寄件者: [REDACTED]
寄件日期: 2025年08月22日星期五 17:54
收件者: Sheren Si Wai LEE/PLAND
主旨: FW: Response to the departmental comments
附件: Revised p11 of S16 Form.pdf

Response to the comment of UD&L Section, PlanD:

Response to the comment of STN DPO, Plan D:

Location Plan of Tree

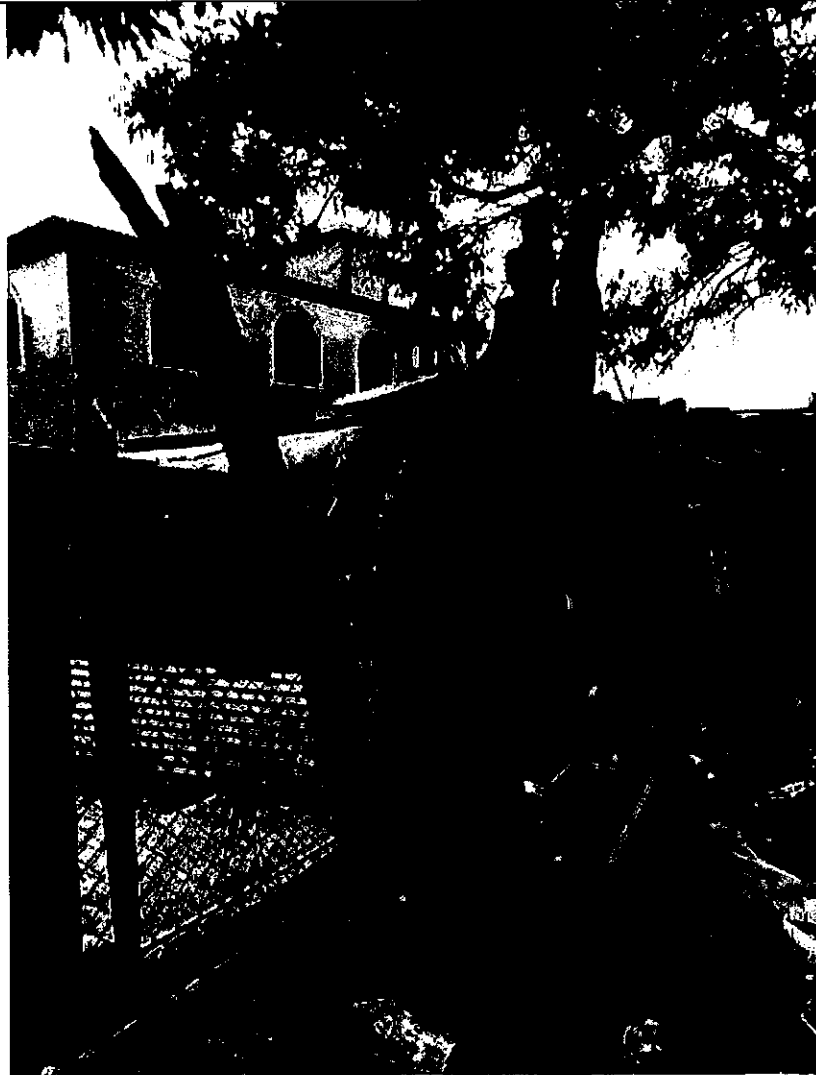
According to our site inspection carried out on 1.8.2025, the site is fenced-off and generally covered with existing trees/vegetation. With reference to Dwg. No. LF-01 and Part 6(A)(e)(ii) of Application Form No. S16-III, a total area of 277.62m² (out of the total site area 839.5m²) will be filled with about 0.2m in depth. However, it is stated Part 6(A)(e)(iii) of Application Form No. S16-III that no tree felling will be involved. The applicant should clarify whether the development proposal would cause any adverse impact to the existing trees and advise the proposed tree treatment with associated mitigation measures, if any.

There are a total of 7 trees on site, with a diameter of 200-250mm and a height of about 6 meters. One of them has withered (see attachment). Since the trees are located in the cultivated area and have no impact on the existing application, the applicant decided to retain them and only remove the surrounding weeds.
